Victorian Society Testimony for May 20, 2025: Pier A (aka 22 Battery Place) (LPC-25-07606); 16 East 16th Street (LPC-25-08741); Verdi Square (LPC-25-06032); 157 East 78th Street - Individual Landmark (LPC-25-07704)

Approximate time: 1:00; join Zoom by: 12:00 LPC-25-06032 -- Verdi Square - Scenic Landmark, Manhattan

Close up of the box, clearly labeled "WATER."

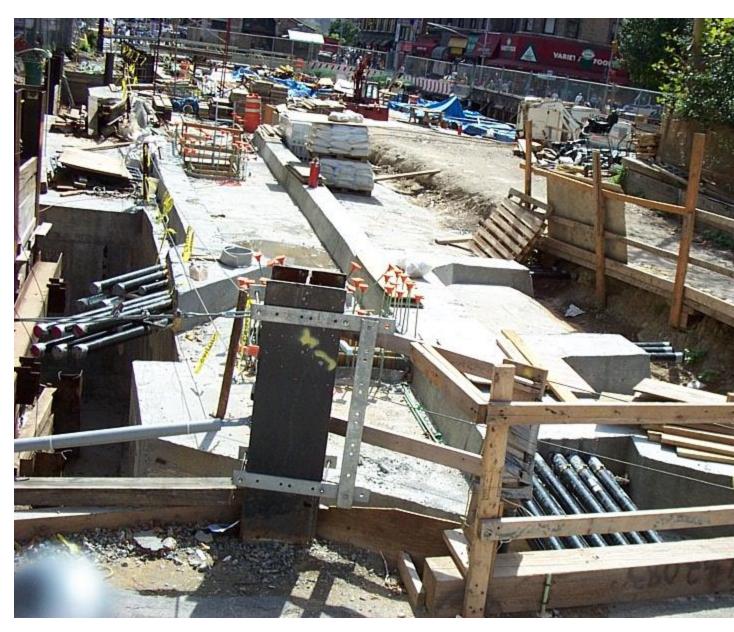
There are two existing hose bibs on the exterior of the new subway station building. These were intended to provide water for the plaza and plantings. One of them is just two feet from the west garden. We ask that the Commission work with Parks to investigate the use of these hose bibs by the volunteer gardeners. This will save hundreds of thousands of

The blue arrow shows the hose bib box on the north side of the new station entrance. This is immediately adjacent to the west planting bed, on the right. There is a second hose bib on the south side, closer to the scenic landmark part of the site.
